NOTE TO: PDIV-1 File  
FROM: *TWA* Tom Alexion  
SUBJECT: LICENSEE'S DRAFT RESPONSES TO NRC'S JUNE 13, 1997,  
REQUEST FOR ADDITIONAL INFORMATION ON GRADED QUALITY  
ASSURANCE, SOUTH TEXAS PROJECT, UNITS 1 AND 2  
(TAC NOS. M92450 AND M92451)

South Texas Project  
Unit 1 and Unit 2  
Docket No. STN 50-498 and STN 50-499  
Response to Request For Additional Information of June 13, 1997  
Regarding the South Texas Project's Graded Quality Assurance Program

Response To NRC Request for Additional Information of June 10, 1997 on the Graded  
Quality Assurance Program

GRADED QUALITY ASSURANCE PROCESS FLOWCHART

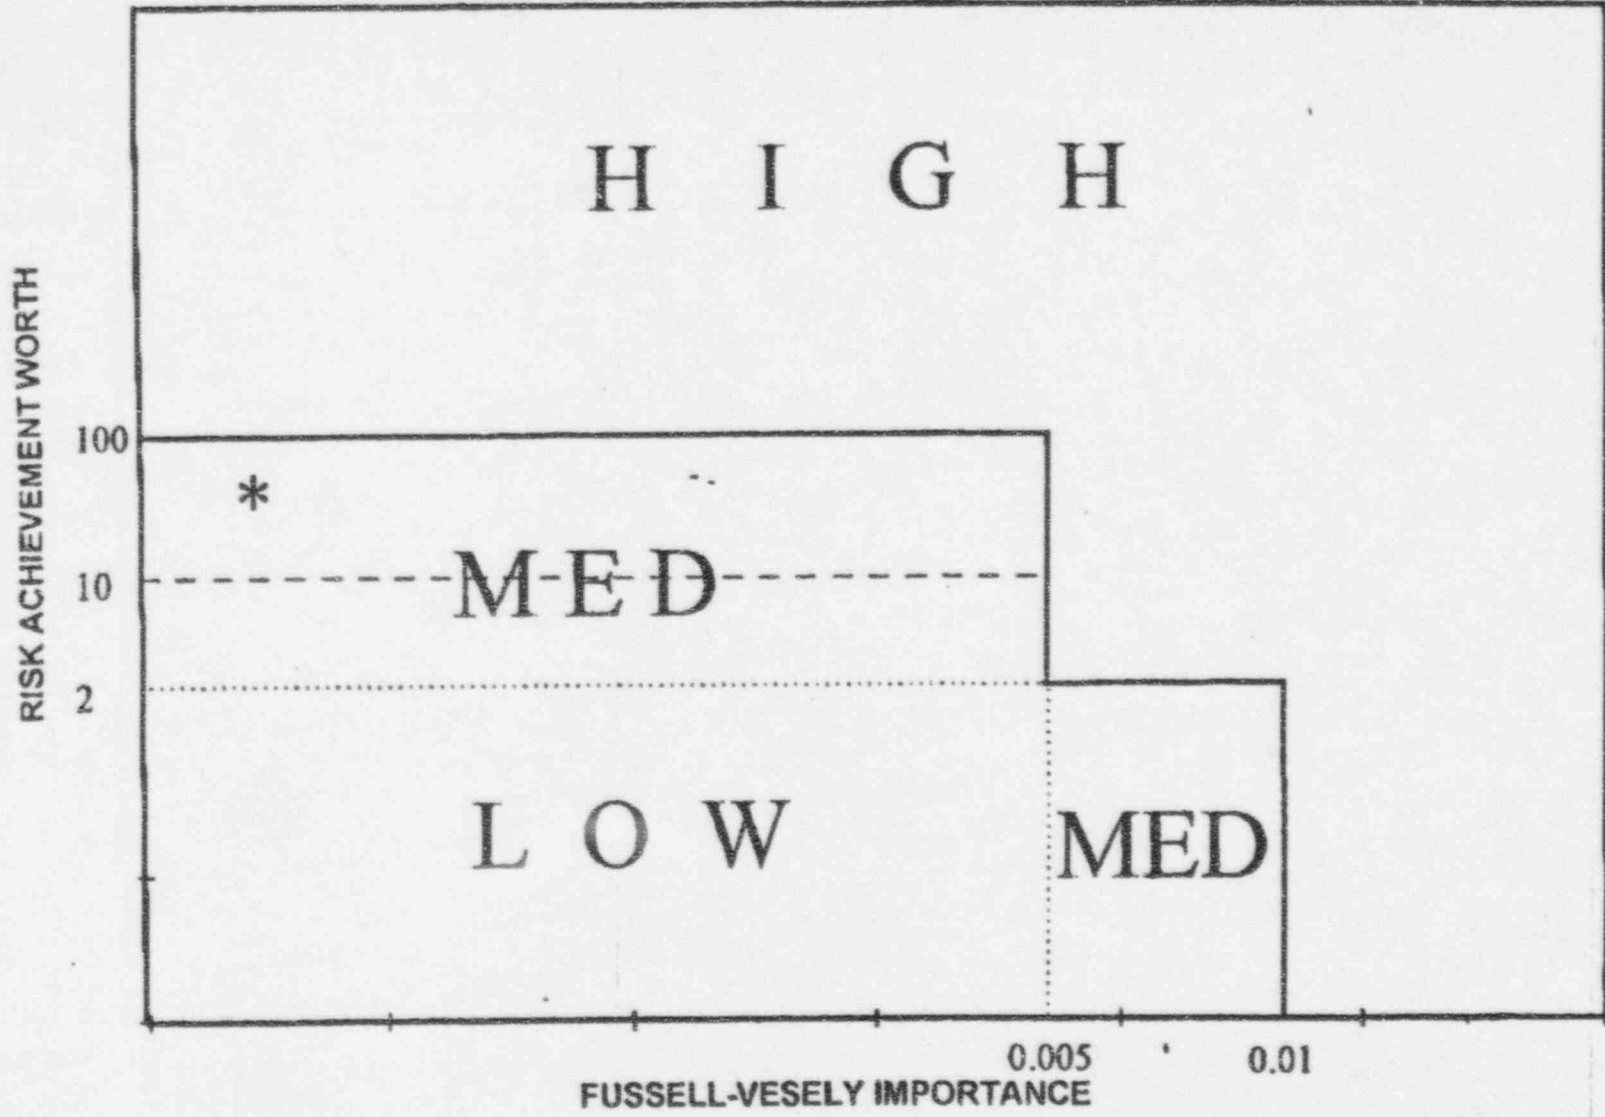
During the May 5-8, 1997, site visit NRC expressed concern that placing components with a risk achievement worth (RAW) greater than 10 but less than 100 in the Basic program may be inappropriate. NRC requested that HL&P identify this population of components in the QA program description, and describe how specific QA controls would be assigned to the components' critical attributes. NRC has not found a satisfactory resolution to this concern in the May 21, 1997, revised submittal. NRC requests that STP change the QA program description to:

- include a clear definition of the population of components in question. These components are currently categorized as medium safety-significant which provides no distinction from other medium safety-significant populations. NRC is willing to consider the acceptability of a definition of this population which does not include numerical guidelines in the OQAP, but the basic attributes of the population (e.g., high reliability yet a high impact on risk if problems develop) must be clearly described.

- provide a description of how QA controls will be assigned to the critical attributes of this population of components. As discussed, NRC does not find that simple application of Basic program controls is sufficient. Nor does NRC find that explicit consideration by the working group and expert panel of the assigned controls is sufficient. NRC is willing to consider the acceptability of assigning

The South Texas Project has changed the Graded Quality Assurance Program to require safety related components with a RAW between 10 and 100 to have FULL Quality Assurance controls applied to the critical attributes associated with that RAW. The OQAP chapter 2, sections 5.3.9 and 5.3.11 have been revised to reflect this change (OQAP change 32 (ST-HL-AE-5668)).

The Comprehensive Risk Management Procedure, OPGP02-ZA-0003 Addendum 2 has been revised. The flowchart is provided in Attachment 3 which identifies the Probabilistic Risk Importance thresholds used for Graded Quality Assurance component classifications.

\* SR Components with a RAW between 10 and 100 are to have Full QA applied to the critical attributes associated with that RAW

Figure 1  
Attachment 6

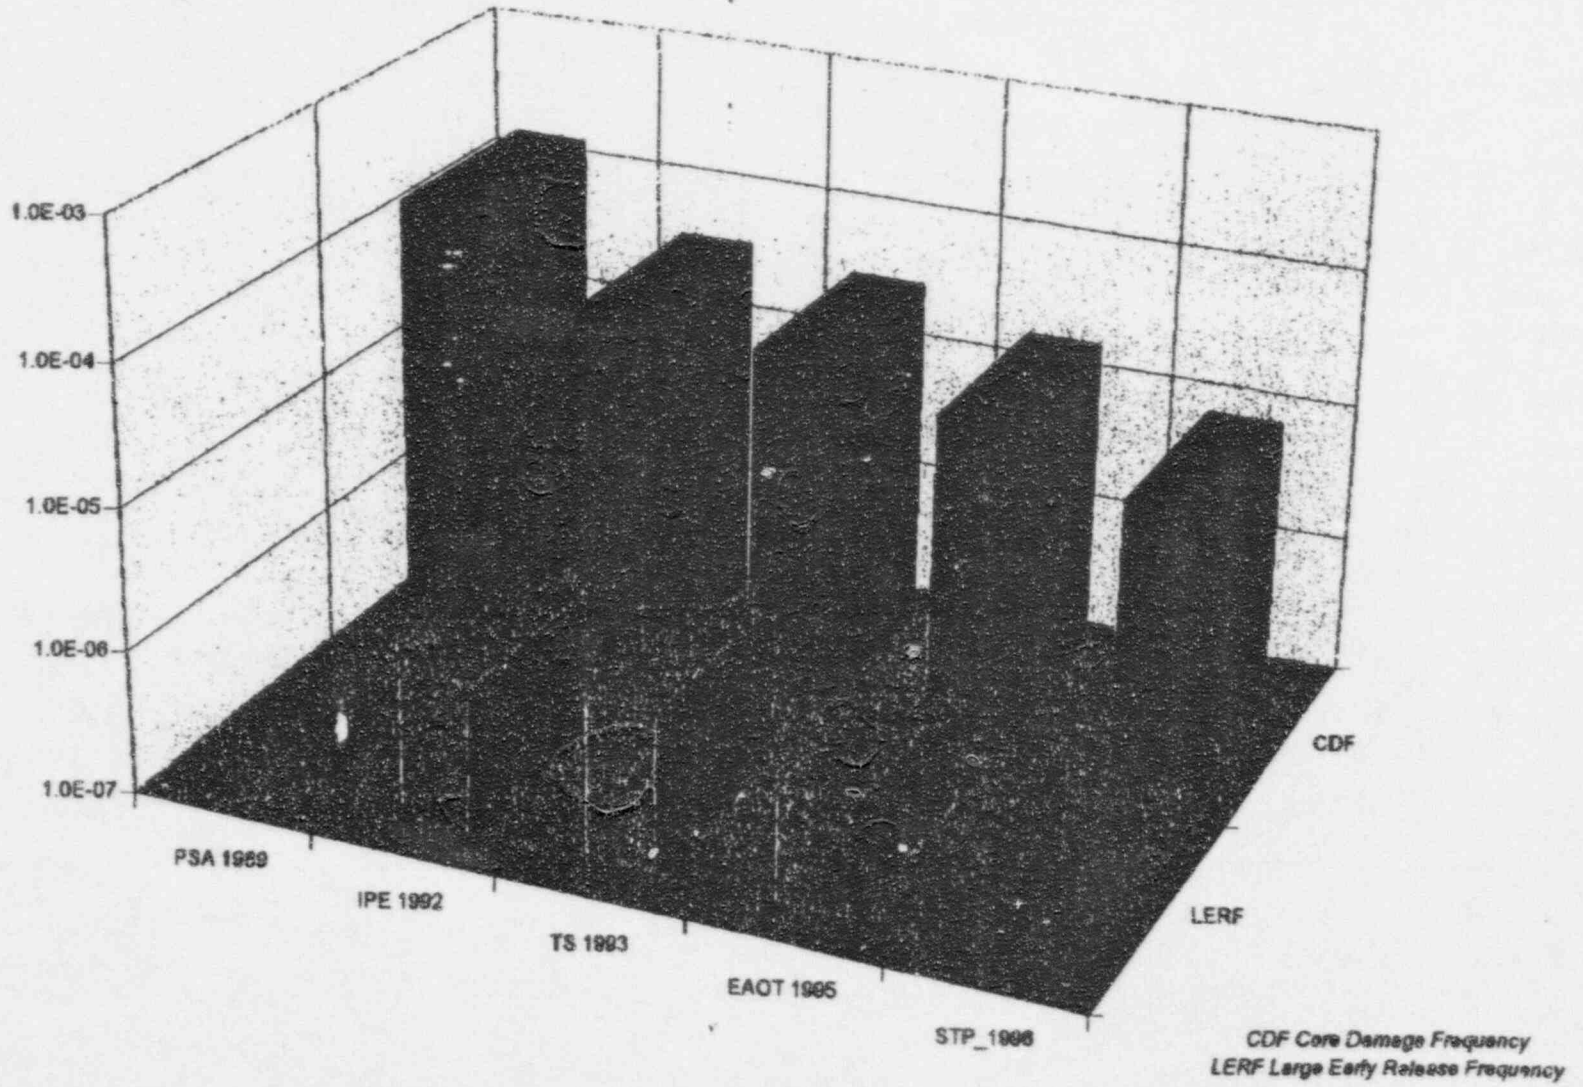
13. *Practices and activities to ensure quality of the South Texas PRA are an important element in justifying use of risk insights as part of the GQA program. It is the staff's understanding that current CDF and LERF values are approximately an order of magnitude lower than in the 1989 (CDF) and 1992 (LERF) baseline studies. Please provide details of processes to ensure that the PRA updates and modifications were correctly implemented. This should include:*

*a listing of the modifications made to the PPA, the reason for each change and a discussion of the impact on the plant's risk profile.*

The staff is correct in its understanding that the current CDF/LERF values are approximately an order of magnitude lower than the referenced baseline studies. Continuous improvement of South Texas Project's PRA has always been an element of focus. Major PRA applications, such as the recent Diesel Generator Extended Allowed Outage Time (DG EAOT) request, have always contained updated PRA information. Listed below are the major PRA efforts at STP which required model updates along with the associated calculation for CDF and LERF (See also Figure 1 in Attachment 6).
